Hammersmith Bridge – Temporary Vehicle Bridge

Beckett Rankine Proposal

Analysis of the Beckett Rankine proposal:

Appendix A: Plan of Bridge with highlighted areas of concern

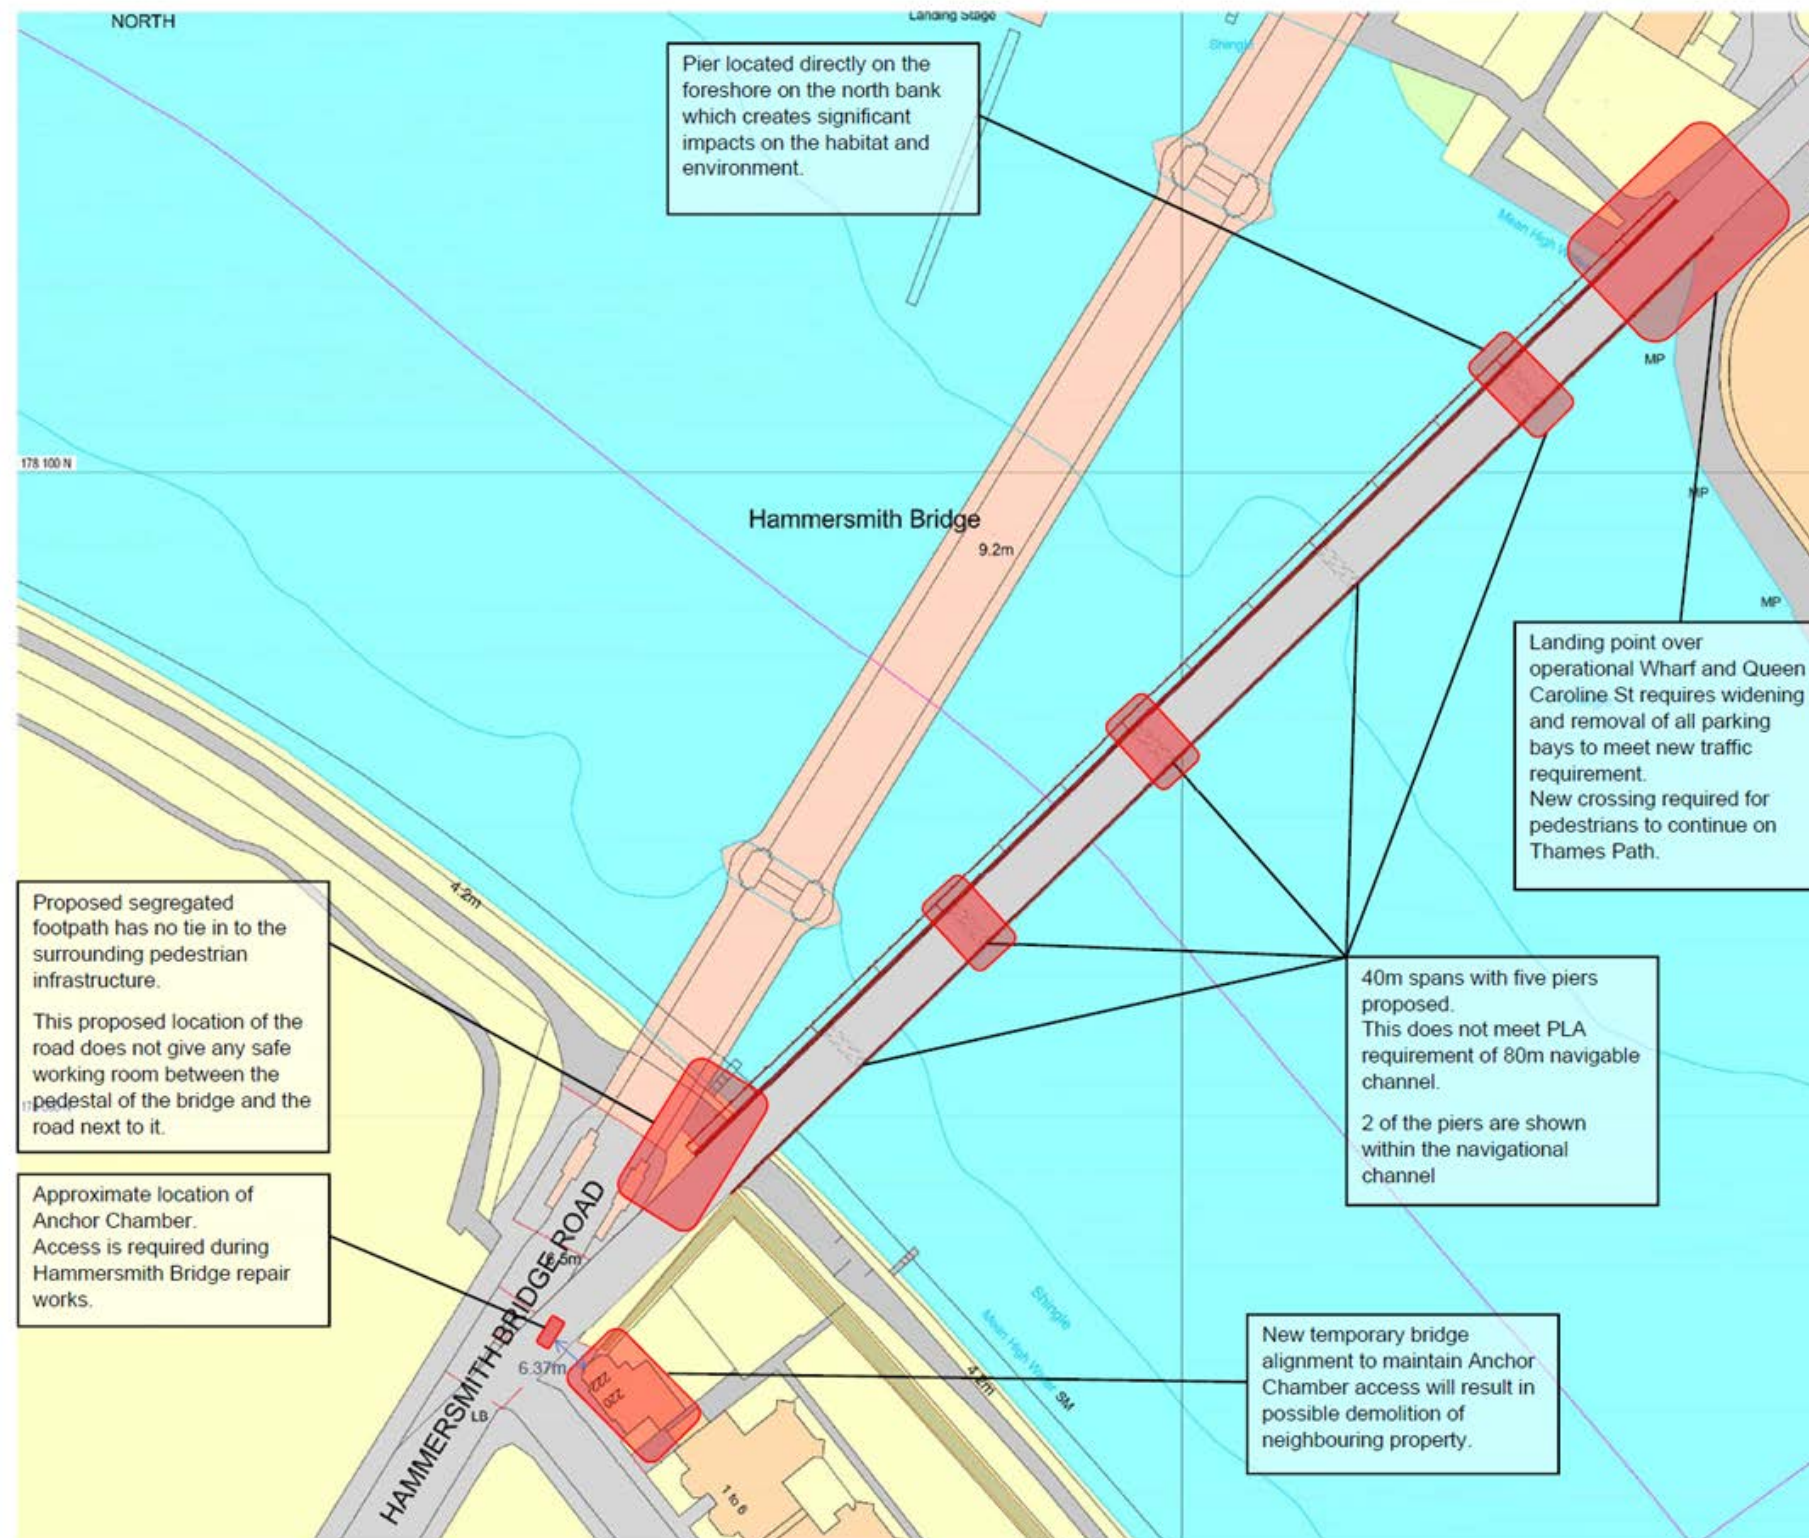
- (i) The Beckett Rankine proposal has bridge spans of 40m with piers located within the main river (navigable) channel. For safety of river traffic the PLA require the main river channel to be free of any piers with a bridge span of 80m. This span isn't achievable using the proposed Retro Heavy Bridge put forward by Beckett Rankine, which has spans of up to 51m. TfL has looked at Retro Bridge's other solutions that would support a longer span (the Retro Panel Bridge or Retro Long Span Bridge), although these only provide for up to 76.2m. Furthermore, the

- (ii) They have located a pier within the north bank foreshore which the EA have indicated would be unacceptable, as this would create significant impacts to habitat and wildlife.

- (iii) Two Piers, on their proposal, are currently shown to be positioned within the navigational channel and how they are aligned to the existing bridge would cause issues for vessels navigating the river and lining up the high point of the bridge in the centre.

A plan of the proposed location of the bridge is shown in Appendix A with areas highlighted showing these issues. The plan is based on the information supplied directly from Beckett Rankine.

- (i) It is not clear how pedestrians would access the bridge from the southern end, as the temporary bridge footway abruptly ends without linking into any surrounding infrastructure.

- (ii) There is insufficient space between the temporary bridge and the main bridge at the south-east pedestal. This pedestal requires significant work and therefore to enable this a minimum of 2m clearance is necessary.

- (iii) The access to the south-east anchorage is a man hole currently situated in the pavement. The Beckett Rankine proposal would mean it would be located within the carriageway. Regular access to this (three times a week) is required and could only be done with a closure of this temporary bridge.

- (iv) Junction of Castelnau and Riverview Gardens would need to be remodelled or stopped-up
- (v) Given items (i) and (ii) we believe that the alignment of the temporary vehicle bridge needs to be shifted approximately 4m to the east. This would require the purchase and partial demolition of the private property.
